### **Public Safety & Transportation Committee Report**

### City of Newton In City Council

#### Wednesday, June 7, 2023

Appeal of #TC5-23

# Clark St looking south toward Clark Street (Rowena Road is toward the left)

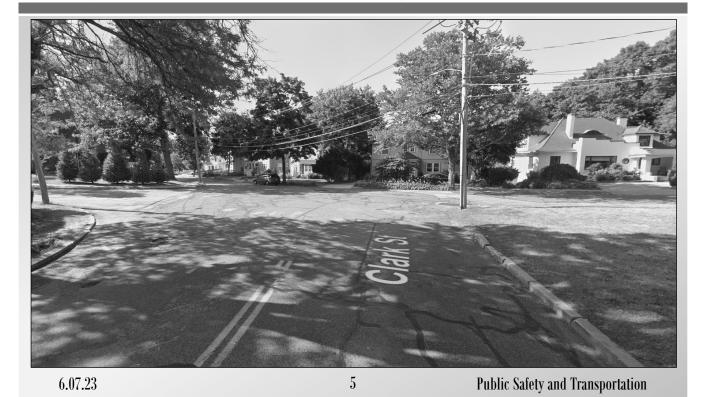
- Clark Street southbound has excellent sightlines to traffic on the Rowena Road approach and the other two Clark Street approaches, as well as to crossing pedestrians. (See MUTCD Guidance 2B.04\_04\_B; MUTCD Guidance 2B.06\_02\_B)

- If drivers can confidently and consistently make safe decisions, then the stop sign is not necessary. Therefore, the presence of a stop sign here will devalue necessary – and meaningful – stop signs elsewhere.

- <u>DPW Response:</u> There is at least one large tree blocking sight lines for Clark Street southbound vehicles looking to on-coming traffic from the east. We disagree that a STOP sign at this location will devalue STOP signs elsewhere.
